"CRC" 38MM-400 CAP				
MOLD-RITE PLASTICS INC. PLATTSBURGH, NEW YORK				
TOLERANCE: +/- .010		DRAWN BY: P.D.T.		
SCALE: FULL		DATE: 1-14-99		DRAWING NO. C-8019

DRAWING REVISION PAGE

SUBJECT: CRC-38mm/400 CAP (Assembled Cap)

DOC: J-8019

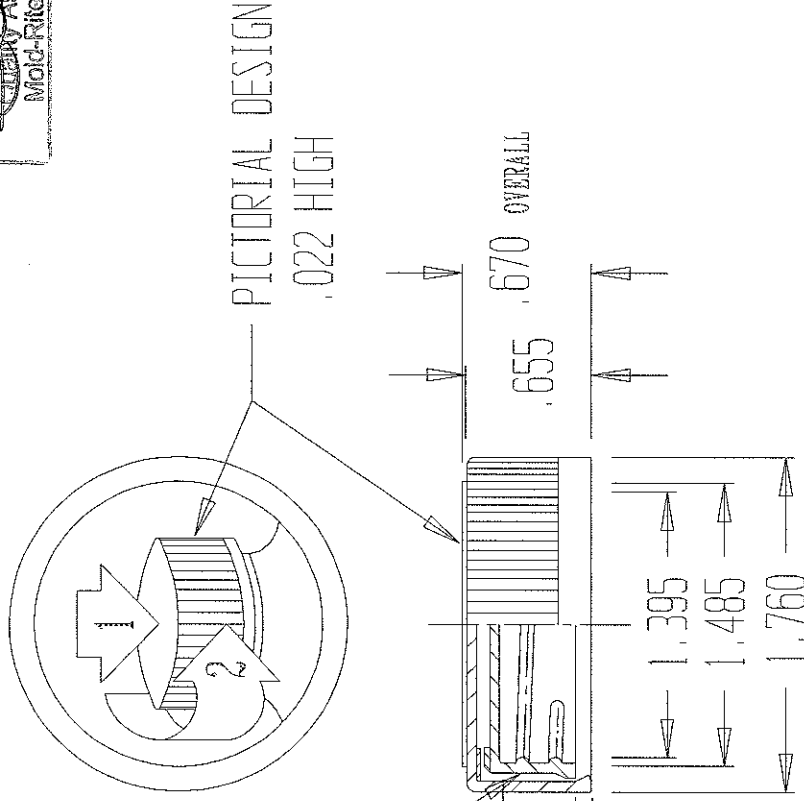
REVISIONS		
REV.	DATE	DESCRIPTION
1	1-14-99	G.C. "B" .670
2	1-14-99	G.C. "B" WITHOUT EMBOSING .665
3	9-13-02	G.C. H dimension- .375

REV LEVEL	REV DATE	DESCRIPTION OF CHANGE
3	Sept. 13, 2002	Changed the "H" dimension to update drawing to actual closure measurement. New measuring equipment with tighter tolerance capability is in use. Added +/- 1.5 grams to weight tolerance. Tolerance was not listed for weight. There was no change to tooling.
